Mercedes-Benz

Campaign No. 2020110005, December 2020

SUBJECT: **Model GLE-Class (167 platform)**
Model Year 2020-2021
Adjust Second Row bench Middle Double Buckle

Figure 3

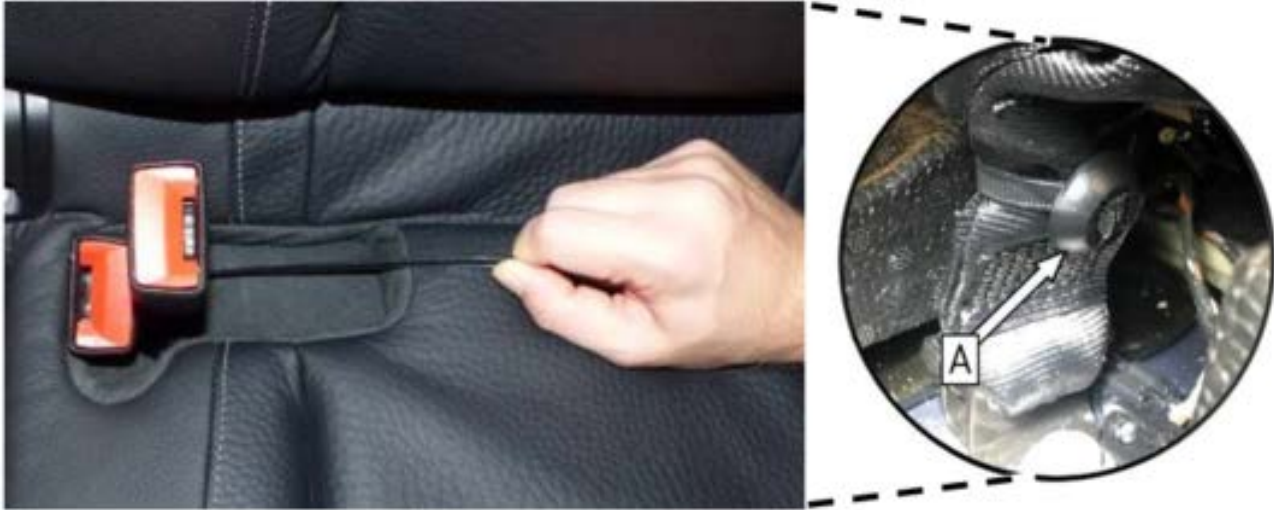
Mercedes-Benz AG (“MBAG”), the manufacturer of Mercedes-Benz vehicles, has determined that on certain Model Year (“MY”) 2020 - 2021 GLE-Class (167 platform) vehicles with 5 passenger seating, in certain circumstances while buckling the seatbelt, the middle seatbelt buckle could be pushed down below the seat cushion. If the passenger is not able to retrieve the buckle, the affected seat would not be available for an occupant to properly fasten the seatbelt. If a passenger does not fasten the seatbelt according to the Operator’s Manual, the risk of injury in a crash could increase. An authorized Mercedes-Benz dealer will additionally secure the middle seatbelt buckle on the affected vehicles to prevent it from being pushed below the seat cushion.

5. Then align "head" of cable tie with left-hand side as shown **(A, Figure 3)**.
6. Use side cutting pliers to cut off overhang of cable tie such that it is flush.
 - i** Make sure that no sharp-edged offcut is left over, as the rear seat cushion cover may otherwise be damaged.
